Form C-103
 October 13, 2009

SUNDRY NOTICES AND REPORTS ON WELLS
 (DO NOT USE THIS FORM FOR PROPOSALS TO DRILL OR TO DEEPEN OR PLUG BACK TO A DIFFERENT RESERVOIR. USE "APPLICATION FOR PERMIT" (FORM C-101) FOR SUCH PROPOSALS.)

2. Name of Operator
Armstrong Energy Corporation

Armstrong Energy Corporation intends to permanently plug and abandon the captioned wellbore as follows:

CURRENT WELLBORE DIAGRAM

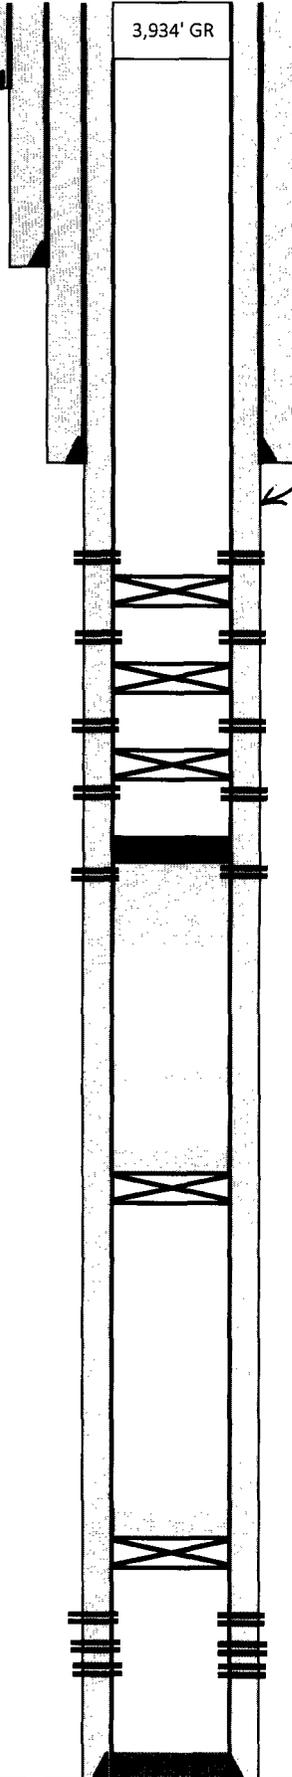
← PERF @ 480 + 5 SQUARE WUC + TAG

← PERF @ 1384 + 50 WUC + TAG
8 5/8" 24# J-55 ST&C @ 1,334' w/700sx, circ.

PROPOSED PLUGGING DIAGRAM

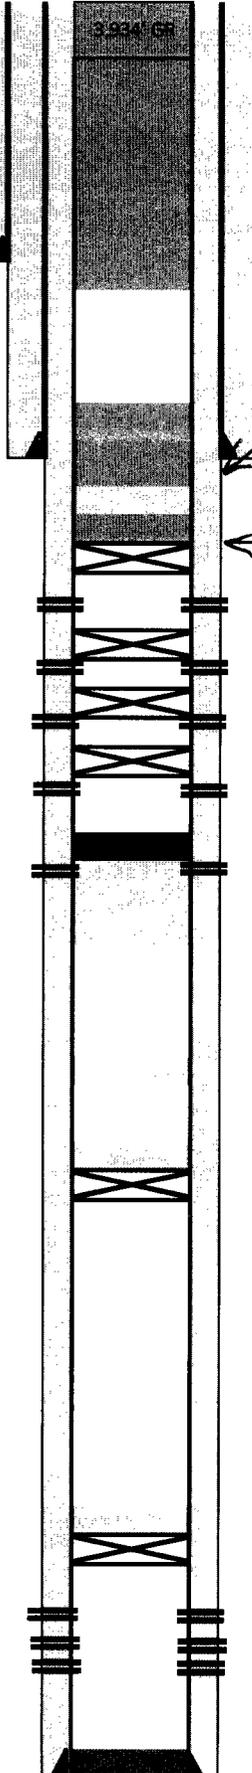
Proposed 50sx cement plug 450' - surface
PERF @ 480' + SQ WOC + TAG

Proposed 100' cement plug 1284'-1384'
PERF + SQ - WOC + TAG @ 1384

Mud Laden Fluid
WOC + TAG
Proposed CIBP @ 2000' w/35' cement

Approved for plugging of well bore only.
 Liability under bond is retained pending receipt
 of C-103 (Subsequent Report of Well Plugging)
 which may be found at OCD Web Page under
 Form 5. www.emnrd.state.nm.us/oecd.

WELL MUST BE PLUGGED BY 11/26/18
